# Staff Report

## Tentative Partition Plat

PA-02-20

**2130 - 2134 Marion St. SE**

**TENTATIVE PARTITION MAP**

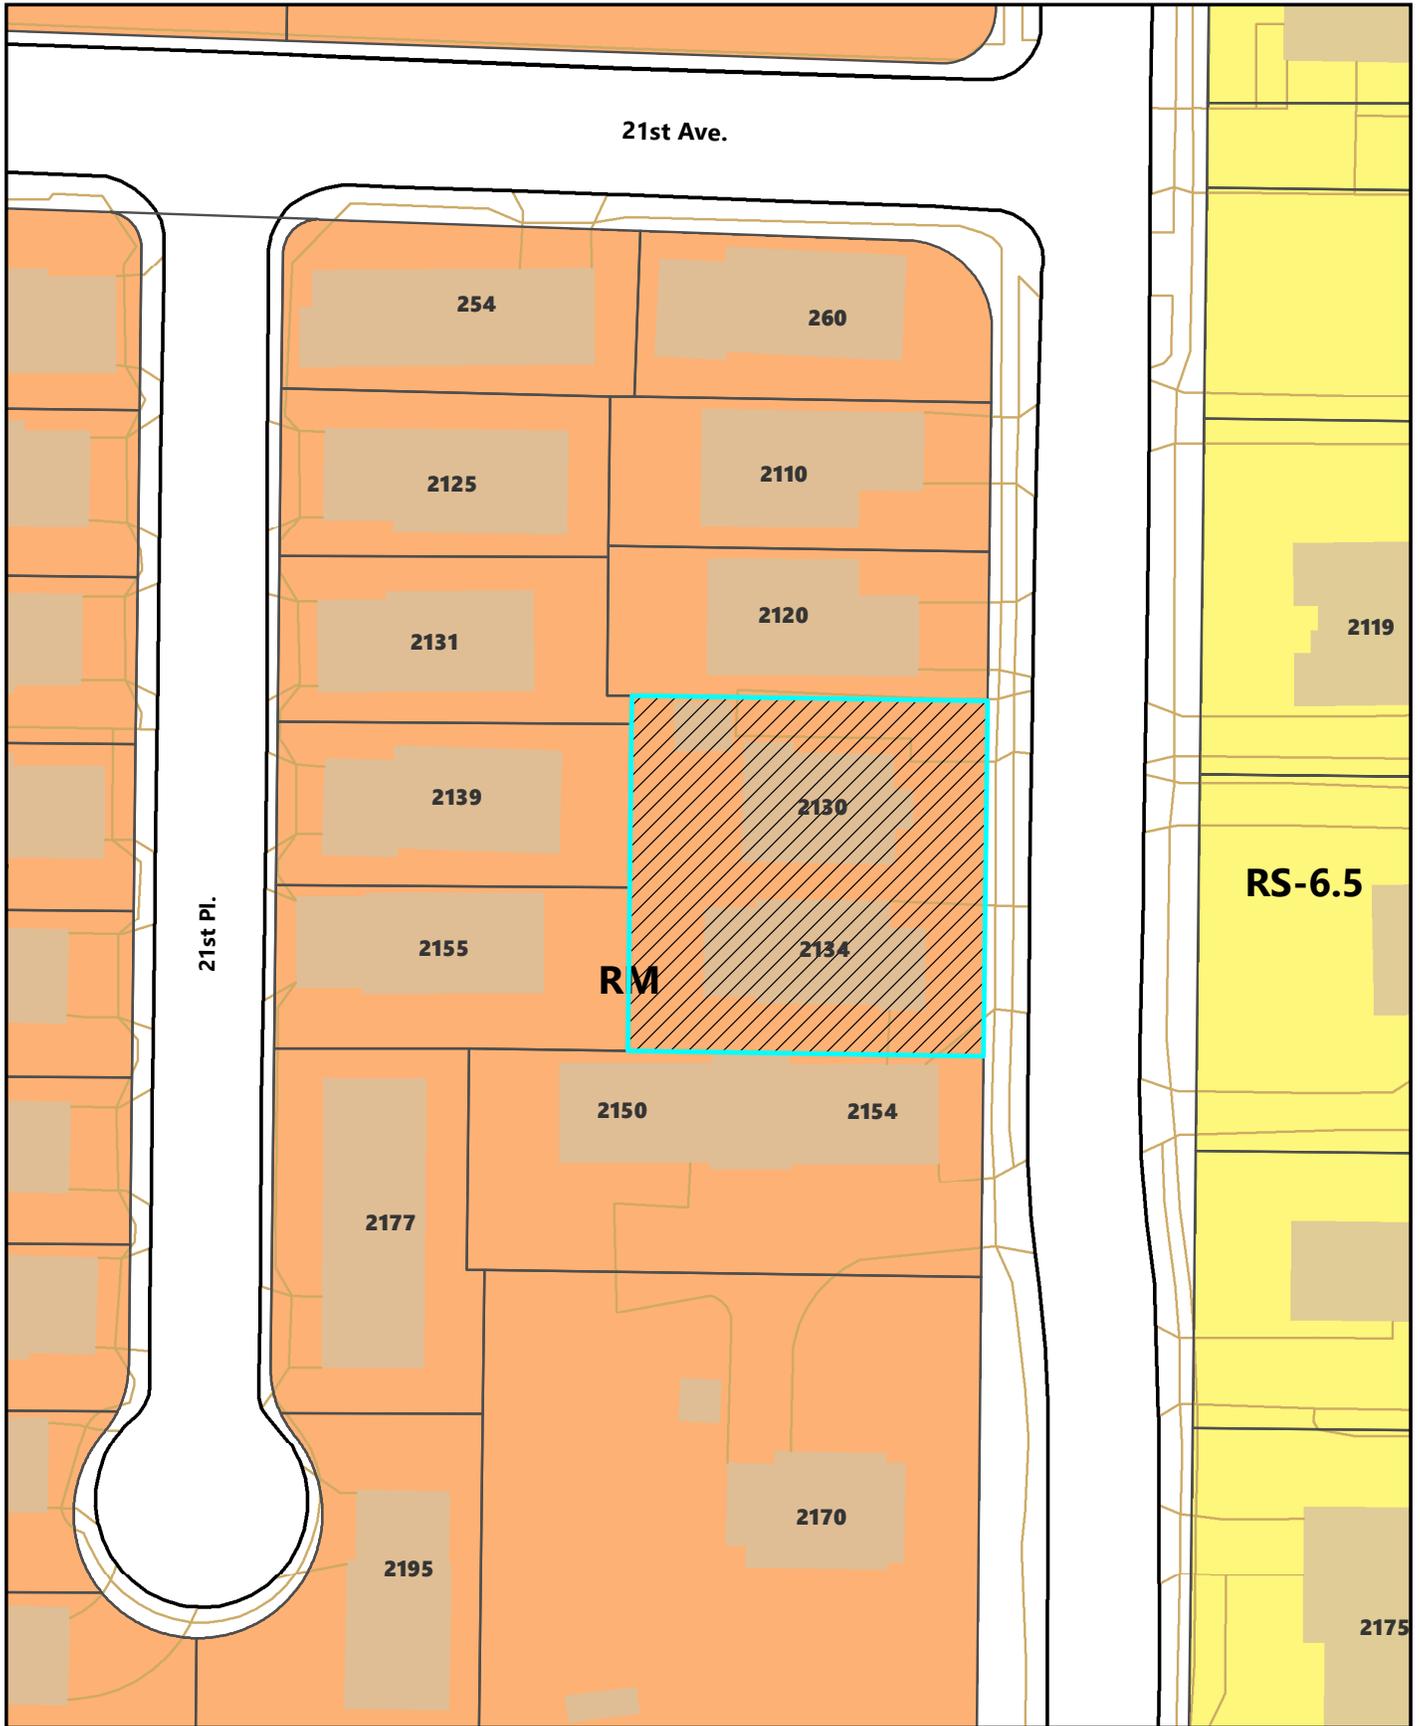
The minimum lot width in the RM zone is 30 feet (for detached single-family dwellings), and the minimum lot depth is 60 feet. As shown on the applicant's tentative partition plat, proposed Parcel 1 will have 5,356 square feet of area, 53.5 feet in width and 100.10 feet in depth, as measured from Marion Street. Proposed Parcel 2 will have 4,655 square feet of area with a width of 46.50 feet and a depth of 100.11 feet, as measured from Marion Street.

The subject property is developed with two detached, single-story, single-family residential dwelling units. Proposed Parcel 1 will consist of a single-story, single-family residential dwelling unit that is approximately 20 foot from the front (east) property line, and 7.73 feet, 30 feet, and 16 feet from the interior property lines. Proposed Parcel 2 will consist of a single-story, single-family residential dwelling unit with attached garage that is approximately 20 feet from the front (east) property line, and 10 feet, 20 feet, and 5.27 feet from the interior property lines. Lot coverage for Parcel 1 and 2 will be 23 percent and 33 percent, respectively.

- 5.3 Each separate parcel must be served by a distinct sewer lateral connection to the public sewer main. This will require that a new sewer service lateral be installed for Parcel 2 along its Marion Street frontage. The applicant must obtain an Encroachment Permit from the City's Public Works Department before doing this work.

- 5.4 City utility maps show a 12-inch public water main in Marion Street. The existing dwellings on the subject property are connected to the public water system through a single water service adjacent to the frontage of proposed Parcel 1.
- 5.5 Each separate parcel must be served by a distinct water service connection to the public water main. This will require that a new water service be installed for Parcel 2 along its Marion Street frontage. The applicant must obtain a water service installation permit from the City's Public Works Department before the City will install the service.

- Condition 1** Before the City will sign the final partition plat, the applicant must have separate sanitary sewer and water services installed for the existing house on Parcel 2, and the private plumbing between the two houses must be abandoned.
